Office Action Summary	Application No. 10/727,060	Applicant(s) SEKI ET AL.	
	Examiner Thinh T. Nguyen	Art Unit 2818

DETAILED OFFICE ACTION

4. Claim 1 is rejected under 35 U.S.C. 102(e) as being anticipated by Sakata et al. (U.S. Patent 6,396) or Iwata et al. (US patent 6,828,888)

Fig.4

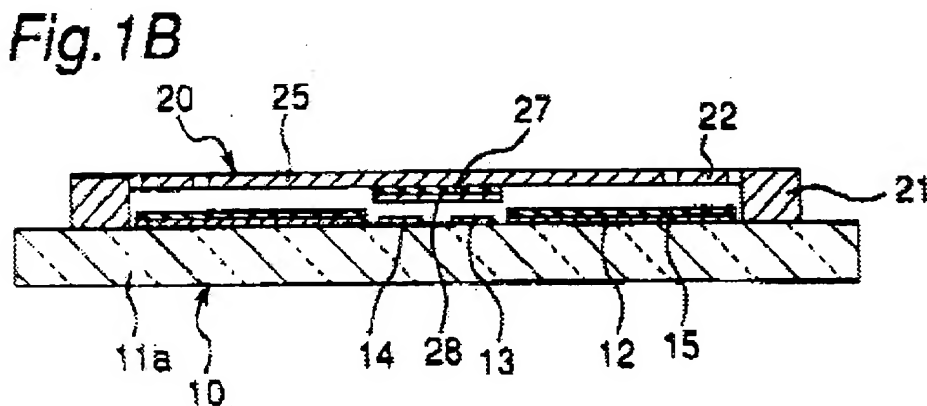
Sakata disclose (fig 1B, fig 4) a contact switch comprising: a first contact (fig 1b,reference 13) provided on a substrate, a second contact (fig 1B reference 28) to be closed or opened with the first contact, and a plurality of signal lines(fixed electrode 12 is the signal line) provided on the substrate, insulated with each other, and connected when the first contact and the second contact are closed, wherein a film thickness of the first contact is smaller than that of the signal line.

FIG. 4

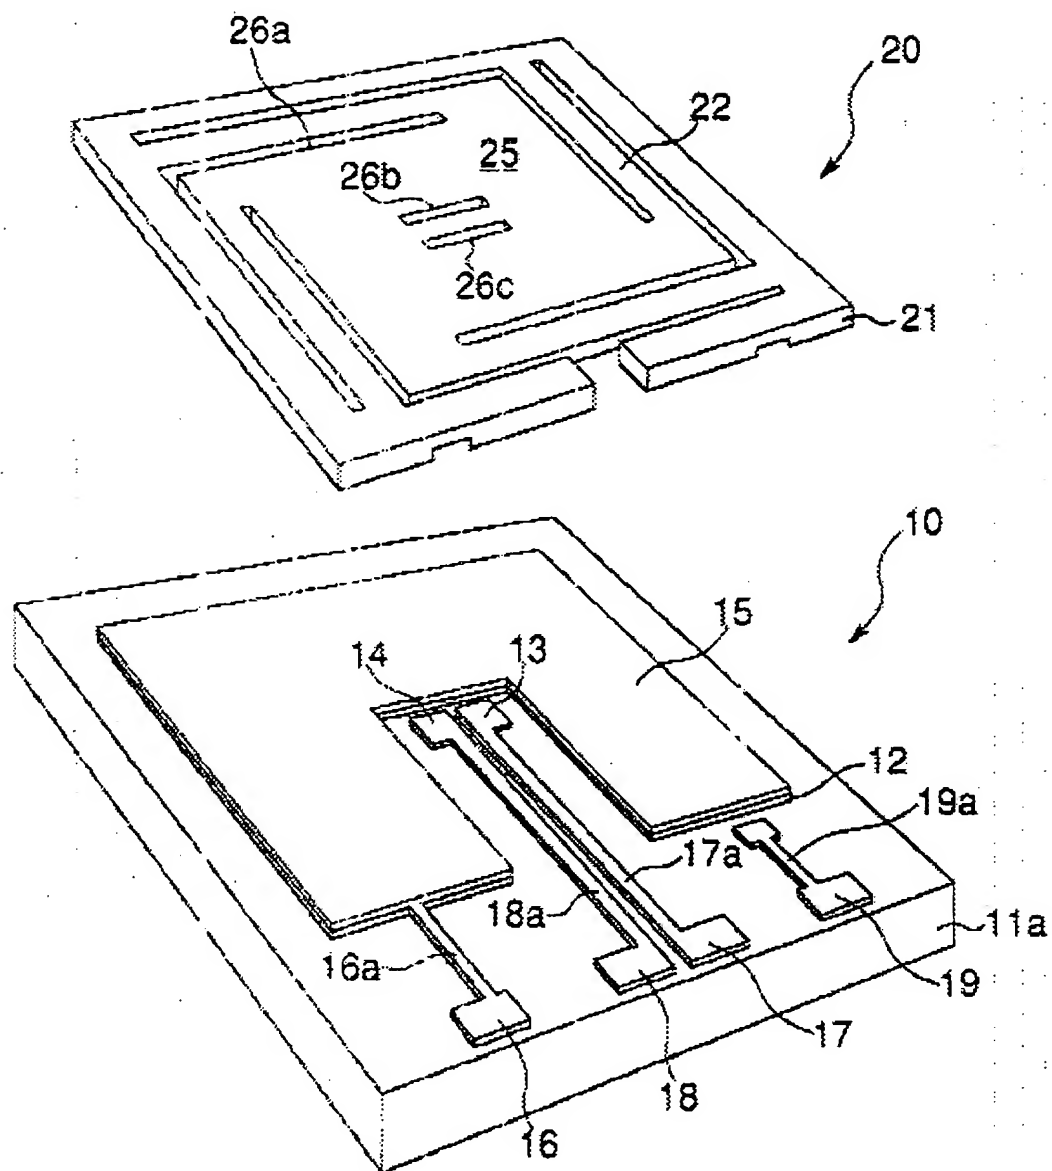
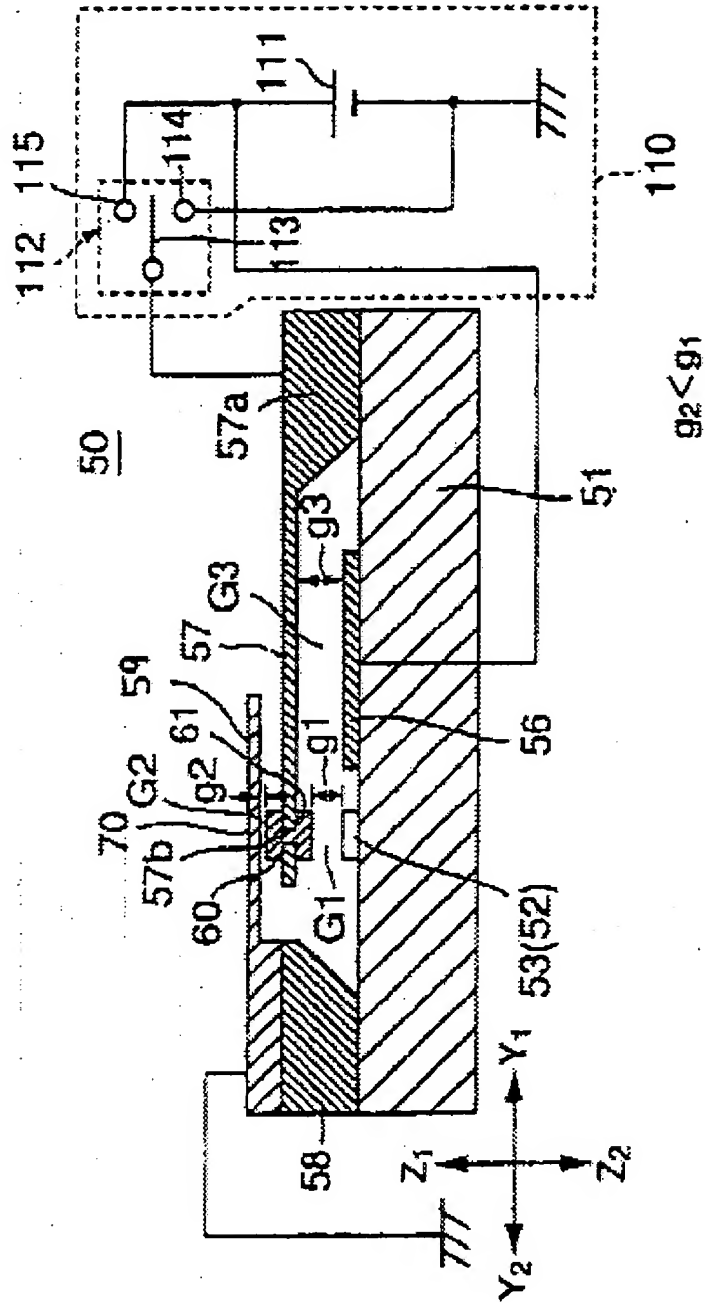
Similarly ,Iwata et al. (fig 4,moving contact 61,fixed contact 53, signal line 57a and 58) disclose the same invention .
